Evaluation of Regulations for the Expansion of the Flower Garden Banks National Marine Sanctuary Expansion

White Paper

October 2016

This is a publication of the Gulf of Mexico Fishery Management Council Pursuant to National Oceanic and Atmospheric Administration Award No. NA15NMF4410011.

Figure 6. Stetson Bank existing FGBNMS boundary (in red), existing HAPC (hatched lines) and proposed expansion (outlined in magenta).

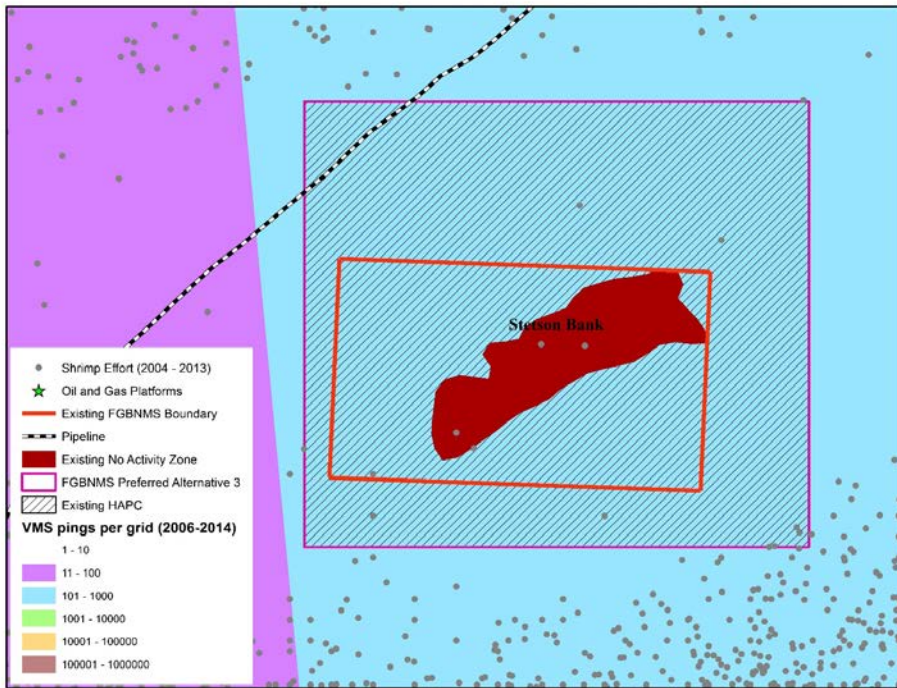
Stetson Bank is already part of the FGBNMS and is a recognized HAPC with fishing regulations (Figure 6). The boundaries of the HAPC and the FGBNMS differ. The Council is currently in the process of initiating a document to review HAPCs, both identifying new areas and revising existing HAPCs. The Council encourages the FGBNMS to maintain the current boundary instead of modifying it to Preferred Alternative 3, as it appears that there has been historic fishing practices in the southeast corner of the HAPC. This area does not appear to be a highly used area for reef fish fishing via VMS data; it should be noted that only bottom tending gear were used in the VMS analysis.

- Establish a truncated “no bottom tending gear zone (including anchors)” for Stetson Bank that coincides with the established BOEM “no activity zone” established
- Prohibit trawling within the boundaries of the proposed expansion of FGBNMS
- Allow anchoring by fishing vessels over soft sediment (anchors used should be specific to anchoring in soft sediment (e.g. Danforth anchors, etc) as long as this area is not in the “no bottom tending gear zone.”
- Allow historic fishing practices in the area to continue as long as they comply with the bottom tending gear regulations and have a FGBNMS endorsement (as described above)
- Modify the southeast portion of the boundary to accommodate shrimp fishing
- ~~Maintain the current FGBNMS boundary and fishing regulations~~

Figure 7. East Flower Garden Bank, West Flower Garden Bank and Horseshoe Bank. Existing FGBNMS boundary (in red), existing HAPC (hatched lines) and proposed expansion (outlined in magenta).

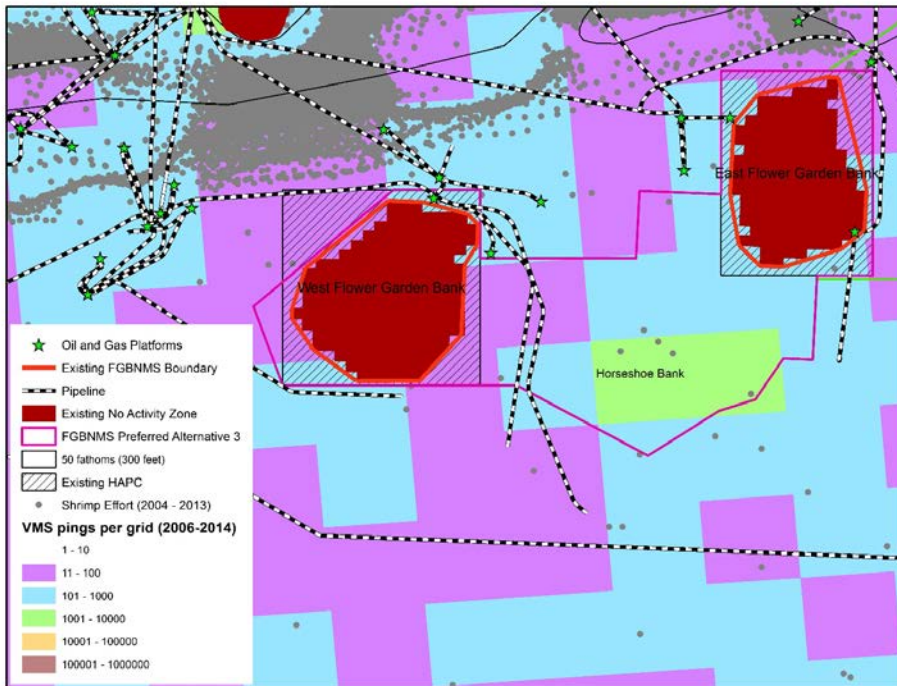
There are sections of the East and West Flower Garden Banks that are already no bottom tending gear HAPCs. However, with the FGBNMS's Preferred Alternative 3, the expansion to include Horseshoe Bank would greatly affect the reef fish fishery in the southeast portion of the proposed boundary (Figure 7). Many of these fisheries operate using anchors in soft sediment, and historic fishing practices should be accommodated as historical oil and gas use is accommodated. All recommendations are based on Figure 7.

- Maintain fishing regulations in the existing HAPCs
- Continue to allow historic fishing practices in the area highlighted in green in the southeast section by the following:
 - Allow anchoring by fishing vessels over soft sediment (anchors used should be specific to anchoring in soft sediment (e.g. Danforth anchors, etc)
 - Allow historic fishing practices in the area to continue as long as it is not over the hard bottom reef
 - Establish a truncated “no bottom tending gear zone” for Horseshoe bank, similar to the no activity zones established over East and West Flower Garden Banks, that would delineate this “no bottom tending gear zone.”
 - In the “no bottom tending gear zone,” prohibit all fishing that is not by hook-and-line and prohibit all anchoring

Figure 9. Gulf of Mexico Fishery Management Council suggested revision to the boundary of the proposed expansion in Preferred Alternative 3.

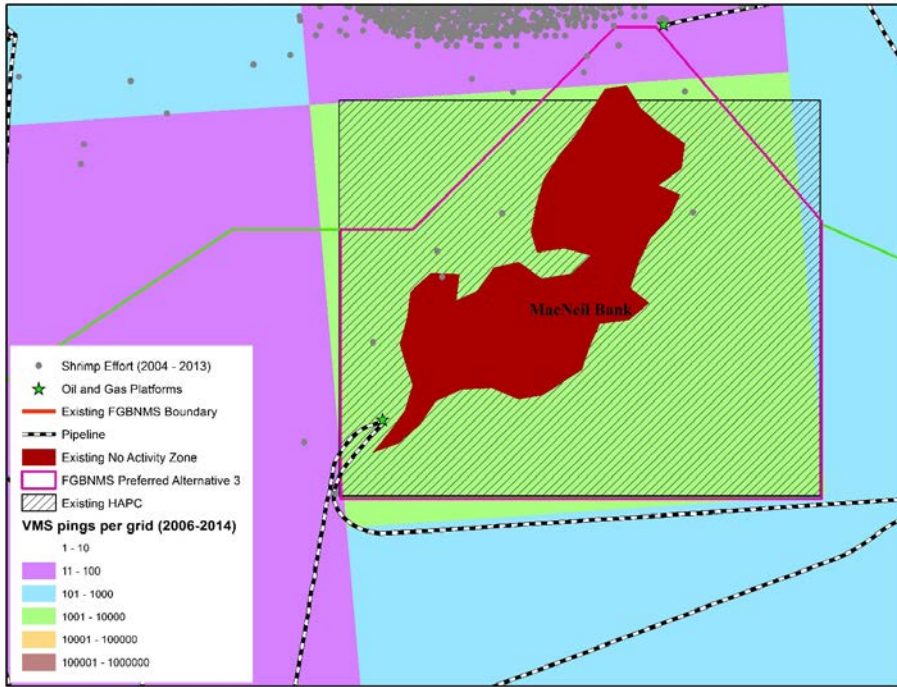
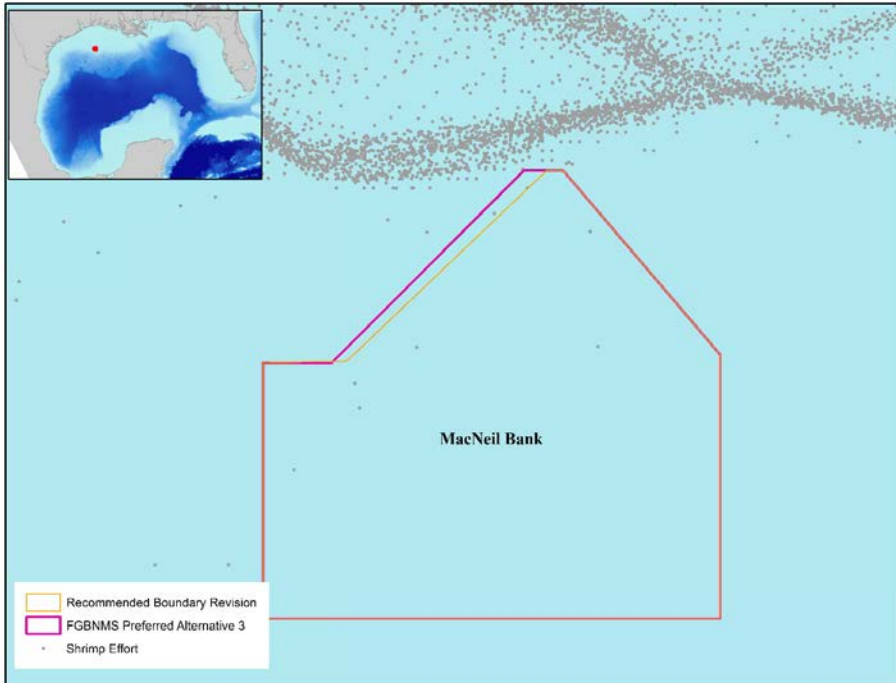
MacNeil Bank is already designated as a HAPC with no fishing regulations (Figure 8). The Council has already provided information to the FGBNMS to revise the proposed northwestern boundary (Preferred Alternative 3) slightly to accommodate the shrimp fishery historic use (Figure 9). All recommendations are based on Figure 9.

- Continue to allow historic fishing practices in the area highlighted in green in the southeast section by the following:
 - Establish a truncated “no bottom tending gear zone (including anchors)” for MacNeil bank that coincides with the established BOEM “no activity zone” established
 - Prohibit trawling within the boundaries of the proposed expansion of FGBNMS
 - Allow anchoring by fishing vessels over soft sediment (anchors used should be specific to anchoring in soft sediment (e.g. Danforth anchors, etc) as long as this area is not in the “no bottom tending gear zone.”
 - Allow historic fishing practices in the area to continue as long as they comply with the bottom tending gear regulations and have a FGBNMS endorsement (as described above)

Figure 10. Rankin, Bright, and 28 Fathom Banks: existing HAPC (hatched lines) and proposed expansion (outlined in magenta).

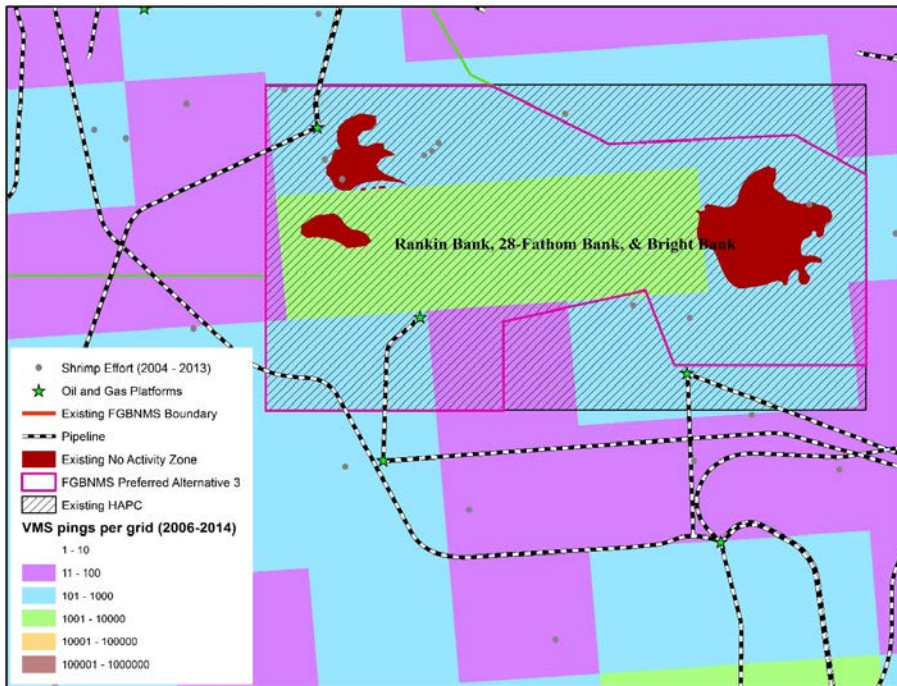
Rankin Bank and Bright Bank are already designated as a HAPC but have no fishing regulations (Figure 10). The green box in Figure 11 is an area of high usage by the reef fish fishery and historic fishing practices should be incorporated into the regulations considered for the FGBNMS expansion. All recommendations are based on Figure 10.

- Continue to allow historic fishing practices in the area highlighted in green in the southeast section by the following:
 - Establish a truncated “no bottom tending gear zone (including anchors)” for Rankin, Bright and 28 Fathom Banks that coincide with the established BOEM “no activity zone” established
 - Prohibit trawling within the boundaries of the proposed expansion of FGBNMS
 - Allow anchoring by fishing vessels over soft sediment (anchors used should be specific to anchoring in soft sediment (e.g. Danforth anchors, etc) as long as this area is not in the “no bottom tending gear zone”
 - Allow historic fishing practices in the area to continue as long as they comply with the bottom tending gear regulations and have a FGBNMS endorsement (as describe above)

Figure 11. Geyer Bank: existing HAPC (hatched lines) and proposed expansion (outlined in magenta).

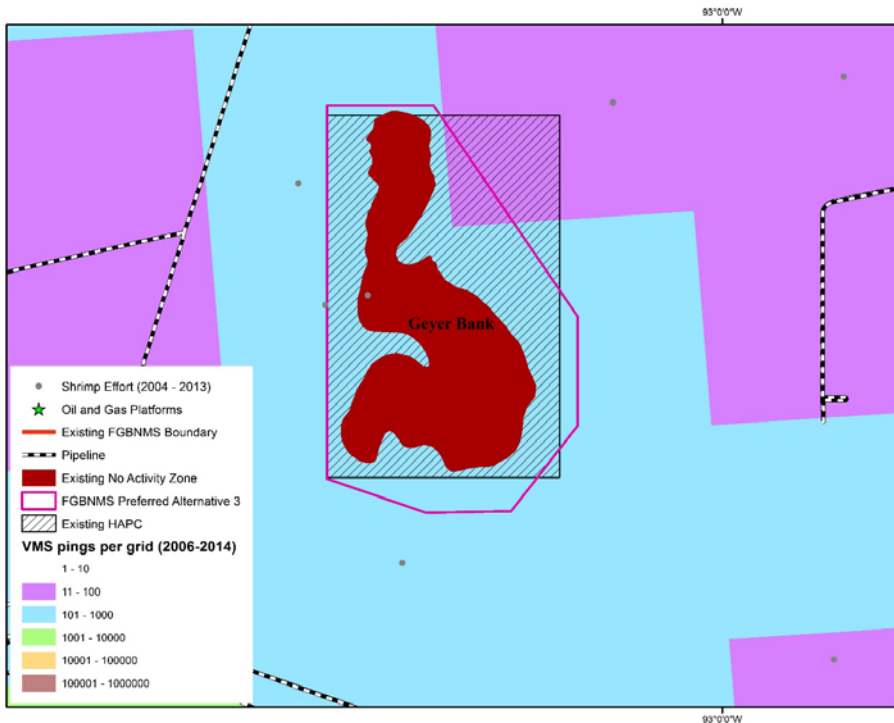
Geyer Bank is already designated as a HAPC but has no fishing regulations (Figure 11). All recommendations are based on Figure 11.

- Establish a truncated “no bottom tending gear zone (including anchors)” for Geyer Bank that coincides with the established BOEM “no activity zone”
- Prohibit trawling within the boundaries of the proposed expansion of FGBNMS
- Allow anchoring by fishing vessels over soft sediment (anchors used should be specific to anchoring in soft sediment (e.g. Danforth anchors, etc) as long as this area is not in the “no bottom tending gear zone”
- Allow historic fishing practices in the area to continue as long as they comply with the bottom tending gear regulations and have a FGBNMS endorsement (as described above)

Figure 12. McGrail Bank: existing HAPC (hatched lines) and proposed expansion (outlined in magenta).

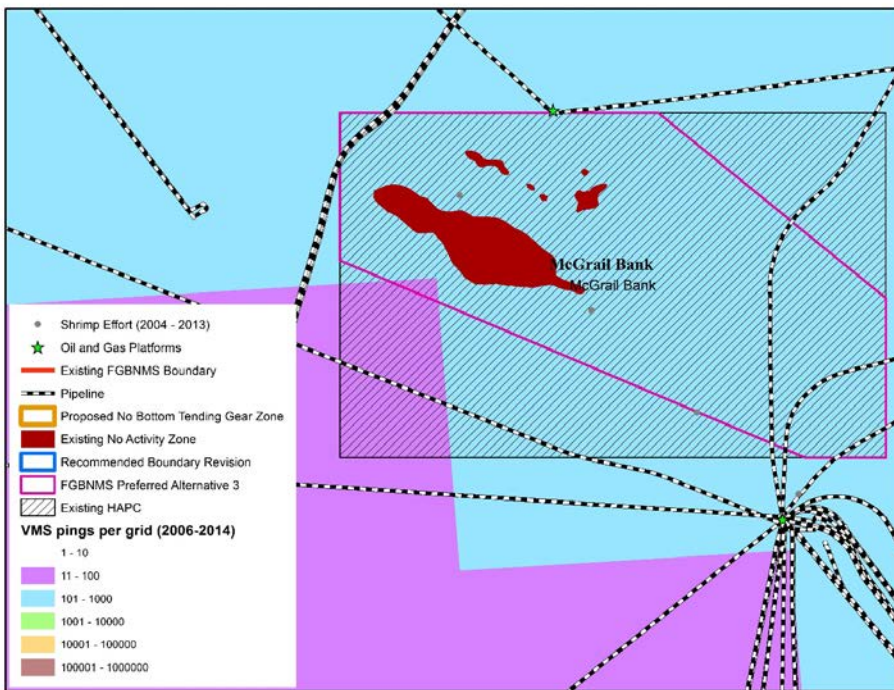
McGrail Bank is already designated as a HAPC with fishing regulations (Figure 12). All recommendations are based on Figure 12.

- Establish a truncated “no bottom tending gear zone (including anchors)” for McGrail Bank that coincides with the established BOEM “no activity zone” established
- Prohibit trawling within the boundaries of the proposed expansion of FGBNMS
- Allow anchoring by fishing vessels over soft sediment (anchors used should be specific to anchoring in soft sediment (e.g. Danforth anchors, etc) as long as this area is not in the “no bottom tending gear zone.”
- Allow historic fishing practices in the area to continue as long as they comply with the bottom tending gear regulations and have a FGBNMS endorsement (as described above)
- There are no regulatory recommendations for this area

Figure 14. Gulf of Mexico Fishery Management Council suggested revision to the boundary of the proposed expansion of Sonnier Bank.

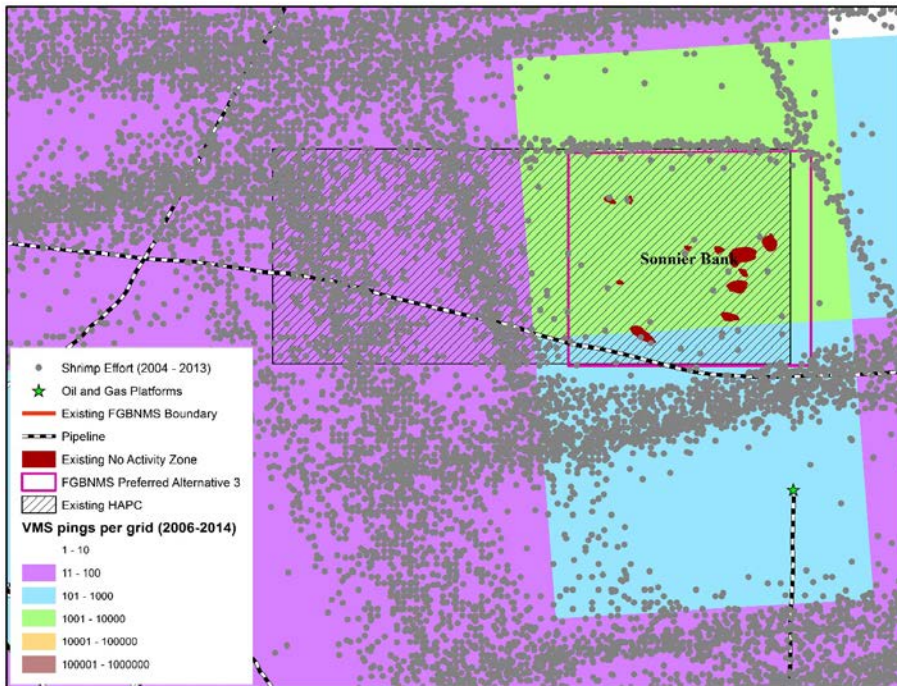
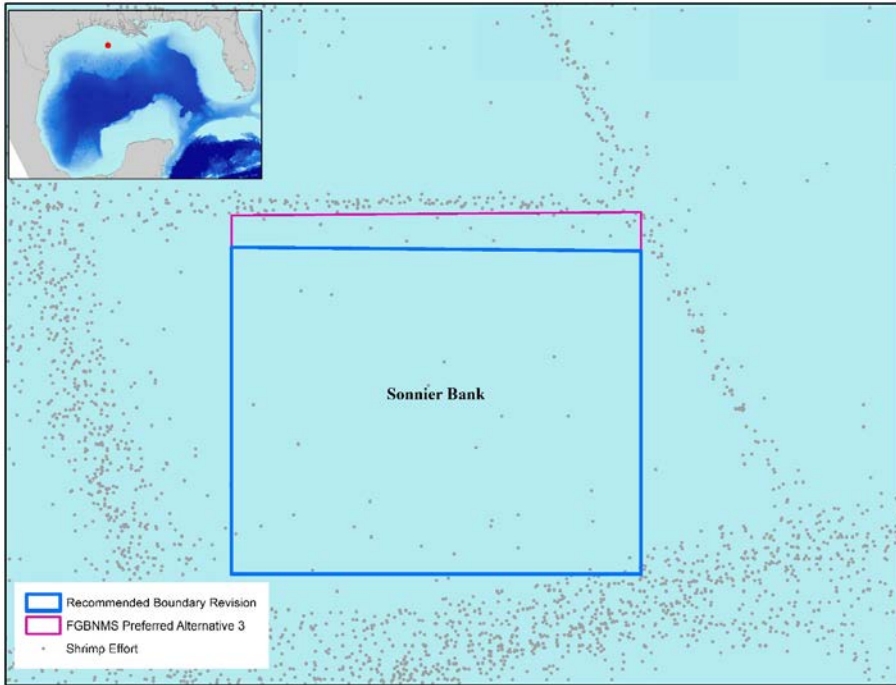
Sonnier Bank is designated as a HAPC but has no fishing regulations (Figure 13). The green box in Figure 15 is an area of high usage by the reef fish fishery and this historic fishing practices should be incorporated into the regulations considered for the FGBNMS expansion. Additionally, the shrimp fishery heavily uses the northern portion of the proposed boundary; the Council has already made recommendations to the FGBNMS about revising the boundary to allow for historical usage (Figure 14). All recommendations are based on Figure 13.

- Continue to allow historic fishing practices in the area highlighted in green in the southeast section by the following:
 - Establish a truncated “no bottom tending gear zone (including anchors)” for Sonnier Bank that coincides with the established BOEM “no activity zone” established
 - Prohibit trawling within the boundaries of the proposed expansion of FGBNMS
 - Allow anchoring by fishing vessels over soft sediment (anchors used should be specific to anchoring in soft sediment (e.g. Danforth anchors, etc) as long as this area is not in the “no bottom tending gear zone.”
 - Allow historic fishing practices in the area to continue as long as they comply with the bottom tending gear regulations and have a FGBNMS endorsement

Figure 15. Alderdice Bank: existing HAPC (hatched lines) and proposed expansion (outlined in magenta).

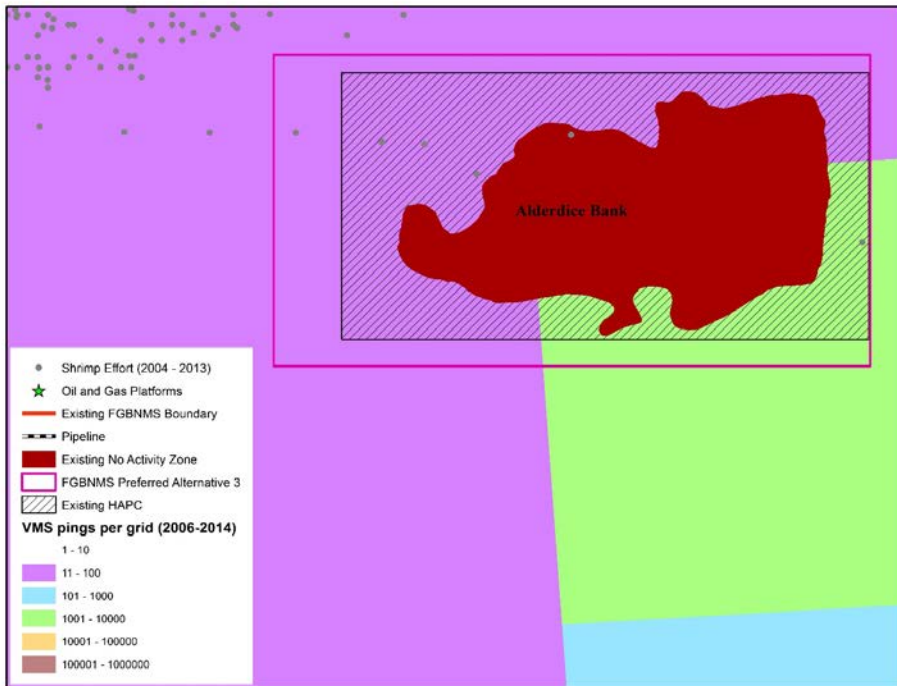
Alderdice Bank is designated as a HAPC but has no fishing regulations (Figure 15). The green box in Figure 15 is an area of high usage by the reef fish fishery and historic fishing practices should be incorporated into the regulations considered for the FGBNMS expansion. All recommendations are based on Figure 15.

- Continue to allow historic fishing practices in the area highlighted in green in the southeast section by the following:
 - Establish a truncated “no bottom tending gear zone (including anchors)” for Alderdice Bank that coincides with the established BOEM “no activity zone”
 - Prohibit trawling within the boundaries of the proposed expansion of FGBNMS
 - Allow anchoring by fishing vessels over soft sediment (anchors used should be specific to anchoring in soft sediment (e.g. Danforth anchors, etc) as long as this area is not in the “no bottom tending gear zone”
 - Allow historic fishing practices in the area to continue as long as they comply with the bottom tending gear regulations and have a FGBNMS endorsement
 -

Figure 18. Gulf of Mexico Fishery Management Council suggested revision to the boundary of the proposed expansion of the Bouma Bank Complex.

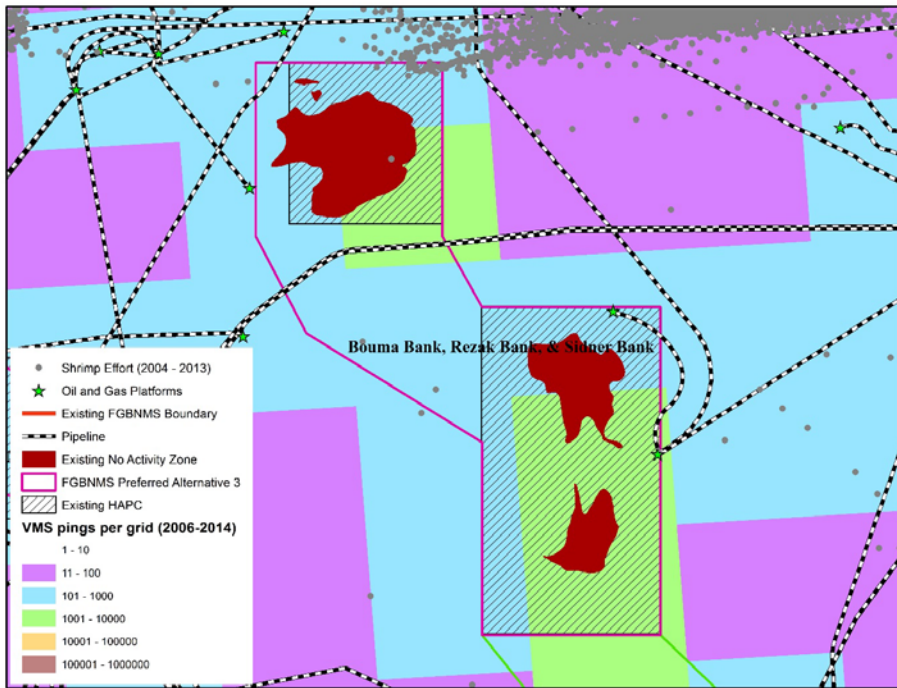
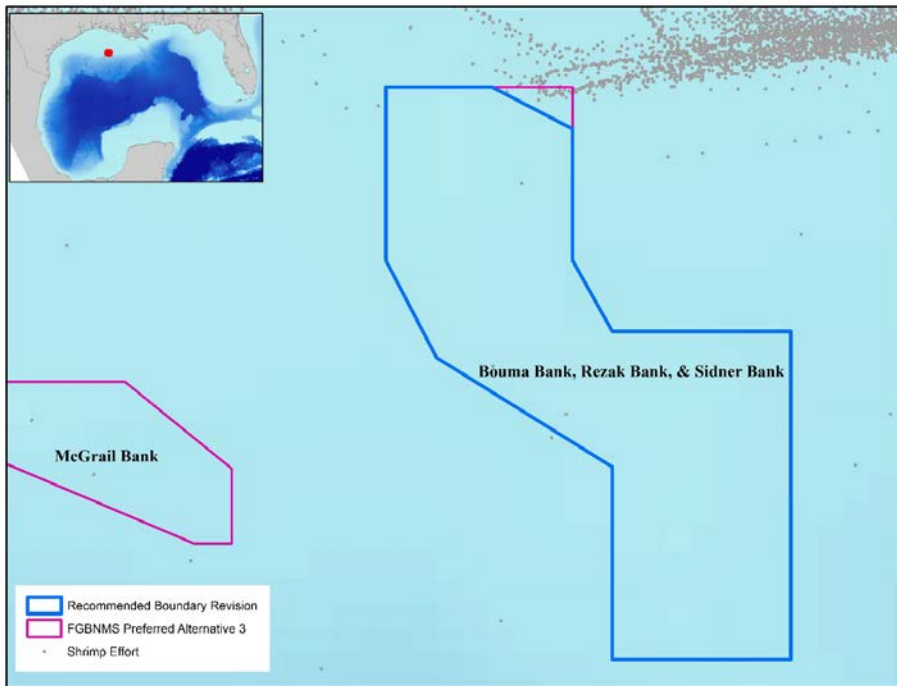
Bouma, Bryant, Rezak and Sidner Banks (Bouma Bank Complex) are designated as HAPCs but have no fishing regulations (Figure 17). The green boxes in Figure 17 are areas of high usage by the reef fish fishery and this historical fishing should be incorporated into the regulations considered for the FGBNMS expansion. Additionally, the shrimp fishery heavily uses the northern portion of the proposed boundary; the Council has already made recommendations to the FGBNMS about revising the boundary to allow for historical usage (Figure 18). All recommendations are based on Figure 17.

- Continue to allow historic fishing practices in the area highlighted in green in the southeast section by the following:
 - Establish a truncated “no bottom tending gear zone (including anchors)” for the Bouma Bank Complex that coincides with the established BOEM “no activity zone”
 - Prohibit trawling within the boundaries of the proposed expansion of FGBNMS
 - Allow anchoring by fishing vessels over soft sediment. Anchors used should be specific to anchoring in soft sediment (e.g. Danforth anchors, etc) as long as this area is not in the “no bottom tending gear zone”
 - Allow historic fishing practices in the area to continue as long as they comply with the bottom tending gear regulations and have a FGBNMS endorsement

Figure 19. Parker Bank: existing HAPC (hatched lines) and proposed expansion (outlined in magenta).

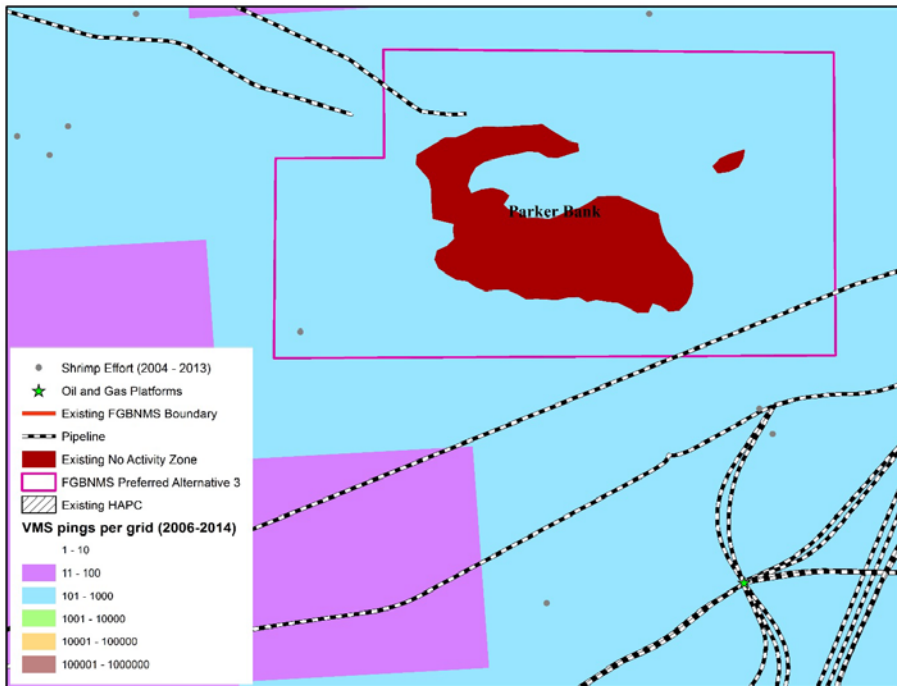
Parker Bank is not a currently designated HAPC (Figure 19) though it was recommended for consideration based on new scientific information by the Council's Coral Working Group in 2014. All recommendations are based on Figure 19.

- Establish a truncated “no bottom tending gear zone (including anchors)” for MacNeil bank that coincides with the established BOEM “no activity zone” established
- Prohibit trawling within the boundaries of the proposed expansion of FGBNMS
- Allow anchoring by fishing vessels over soft sediment (anchors used should be specific to anchoring in soft sediment (e.g. Danforth anchors, etc) as long as this area is not in the “no bottom tending gear zone.”
- Allow historic fishing practices in the area to continue as long as they comply with the bottom tending gear regulations and have a FGBNMS endorsement (as described above)
- ~~There are no regulatory recommendations for this area~~
